RANCHO SECO UNIT 1
TECHNICAL SPECIFICATIONS

3.2 HIGH PRESSURE INJECTION, CHEMICAL ADDITION, AND LOW TEMPERATURE
OVERPRESSURE PROTECTION (LTOP) SYSTEMS

ECN NO. A-4887 Rev. 2

ENGINEERING CHANGE NOTICE

LOW TEMPERATURE OVERPRESSURE PROTECTION (LTOP)
COMPUTER ALARMS - LOGIC DIAGRAM

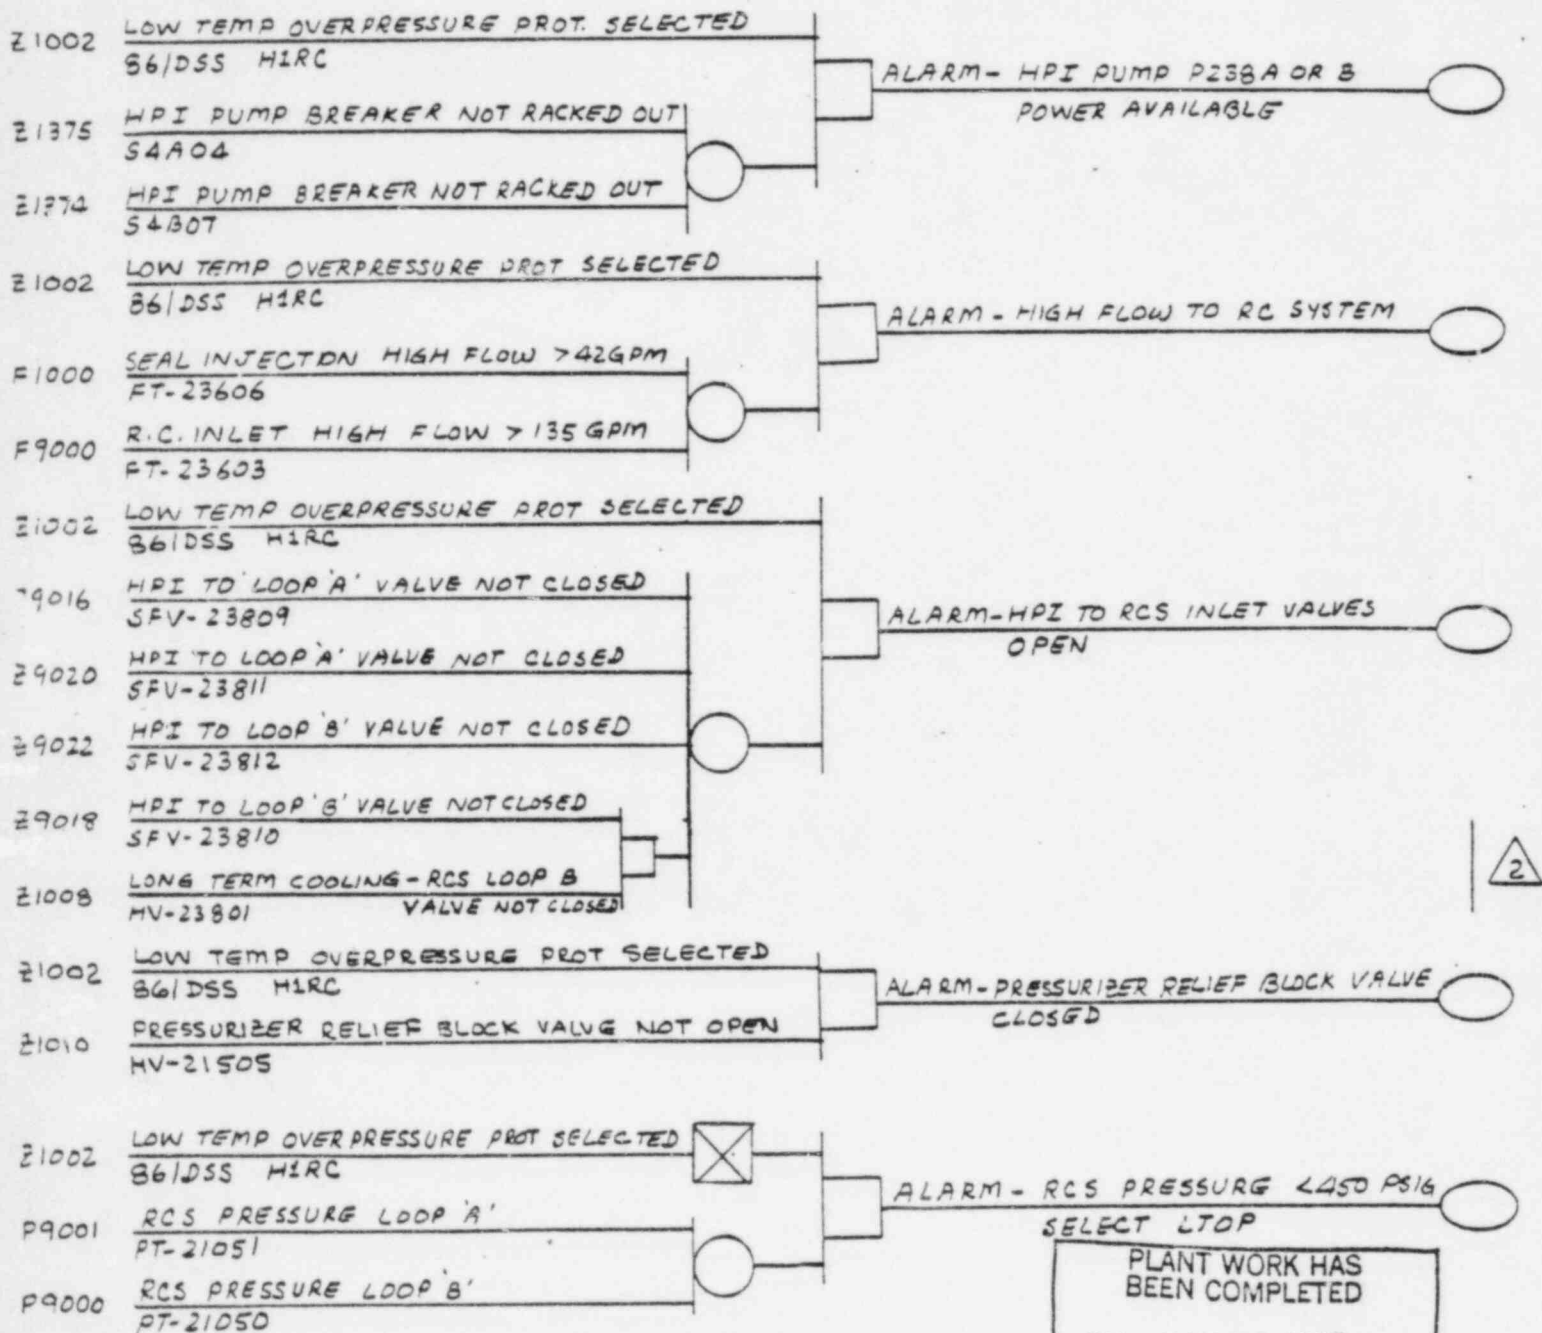
1. Provide an alarm from pressurizer relief block valve HV-21505 to alarm in the control room via IDADS computer if the valve is closed and LTOP is selected. Install cable from HV-21505 to nearest channel B multiplexer.
2. Provide an alarm from HPI pump circuit breakers S4A04 and S4B07 if either breaker is not racked out of its cell, when LTOP has been selected at HIRC. Install cable from S4A04 to H4CDAR3 and from S4B07 to H4CDAR5.
3. Provide an alarm in the control room via IDADS computer from HPI to RCS loop 'B' valve HV-23801 if the valve is open and LTOP is selected. Install cable from H2SFB (valve HV-23801) to channel B multiplexer H4CDAR5.
4. Program the IDADS computer to provide alarms as shown on sheet 2 of 2 of this ECN - LTOP LOGIC DIAGRAM.

LOW TEMPERATURE OVERPRESSURE PROTECTION (LTOP)
COMPUTER ALARMS - LOGIC DIAGRAM

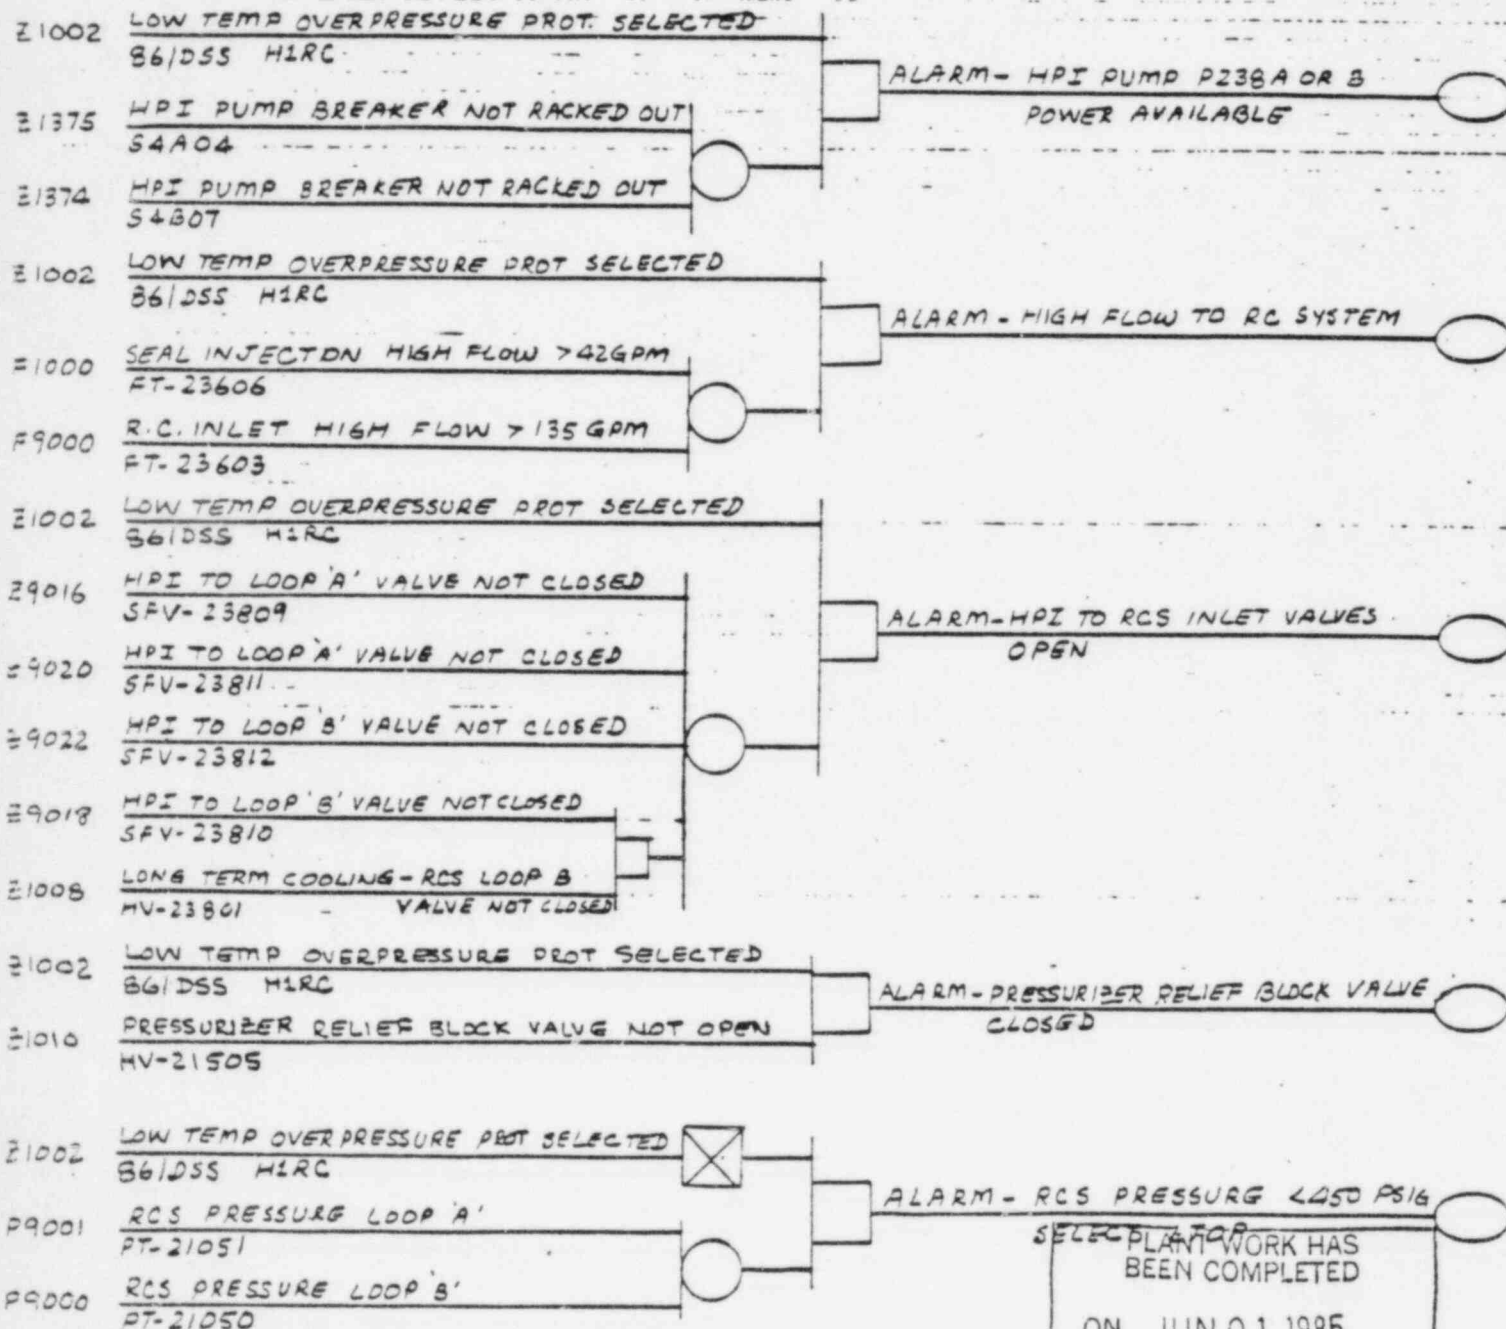
I. Software logic for these alarms is per attached sheet.
